Historic Resources Board Architectural Review Board

Staff Report

Subject: **456 University Avenue [13PLN-00078]:** Request by Robinson Hill Architecture on behalf of Palo Alto Theater Corporation for Historic Resources Board review of exterior modifications to the existing building, including a new storefront window system at University Avenue, new storefront openings at the rear (parking lot side), a new retractable covered canopy over the courtyard, and installation of a bar and restaurant seating in the courtyard for a proposed eating and drinking establishment. Environmental Assessment: a Negative Declaration has been prepared. Zone District: CD-C(GF)(P)

PROPOSED UNIVERSITY ENTRANCE
STREET VIEW OF COURTYARD

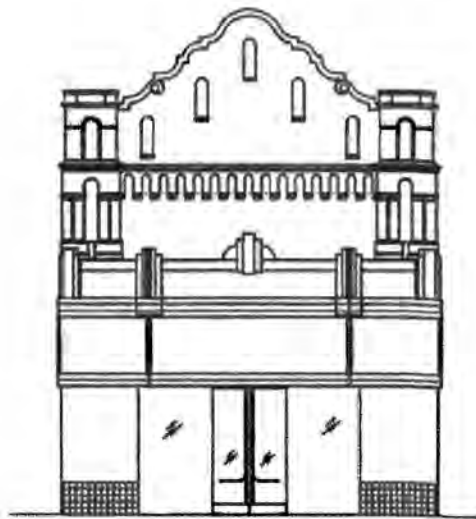
Although the proposed project would not remove or alter the existing structure that compose the entrance forecourt, the addition of a glass storefront system at University Avenue would visually and physically interrupt the open transition to the interior of the building.

Staff can support a new storefront system at the arched opening immediately adjacent to the forecourt. However, given the current description of the glass store front system at University Avenue, staff is not supportive of the current proposal. Staff recommends that the HRB comment on the alteration of the historic main entrance and staff’s recommended approach.

The new glazing system will continue to provide complete visual access to the forecourt at all times and physical access during open hours. Almost every commercial operation facing a street needs a way of securing their facility when it is not open.

The proposed design will have a minimal affect on views into and out of the forecourt space and when open, will provide physical access. There will be minimal impact to the wall and ceiling plaster surfaces where the glazing system touches them. The glazing system is designed to be reversible (Standard 10). Should the glazing be removed at some point in the future, the plaster could be patched and the entry returned to a open entry space. This has already been done where portions of the forecourt plaster were removed and reinstalled as part of the seismic bracing system.

PROPOSED COURTYARD
SIDE SIDE VIEW
TRANSLUCENT FABRIC RAIN CANOPY OPEN POSITION

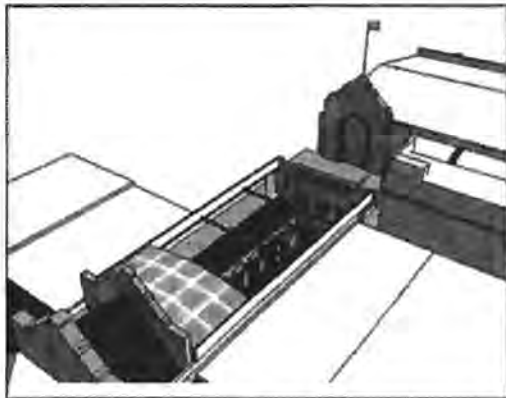
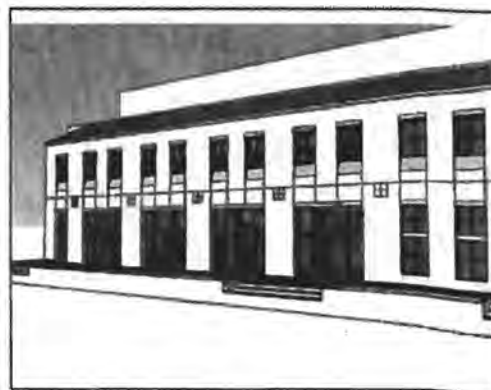
noticeable within the space. This new feature will notably change the open-air qualities of the forecourt by introducing a ceiling-type element to the space.

1. Eliminate or revise canopy solution at forecourt
 - a. Incorporate umbrellas for individual table shading; or consider light, retractable awnings installed at the arcade eave line.
 - b. Investigate alternative solutions that use a less visually intrusive and permanent framework.

The walls above the shed roofs are not historic and were designed to withstand seismic forces, were tied into the new framing, and concrete below. The engineer has determined that the weight of the new canopy can easily be supported by the walls below and the structural calculations will show this. In addition, these walls are property line walls and the parapet walls currently can only be seen from the forecourt as the adjoining property line walls are higher than the theater walls. The parapet trim at the top of the forecourt will be retained and will still serve as the visual terminus for the forecourt. The canopy has been detailed so that it is clearly modern and is set apart from the historic forecourt. The joint between the two is set back from the front of the parapet to create a gap between the two. While the canopy is located above the parapet walls, their height will still be seen as their current height.
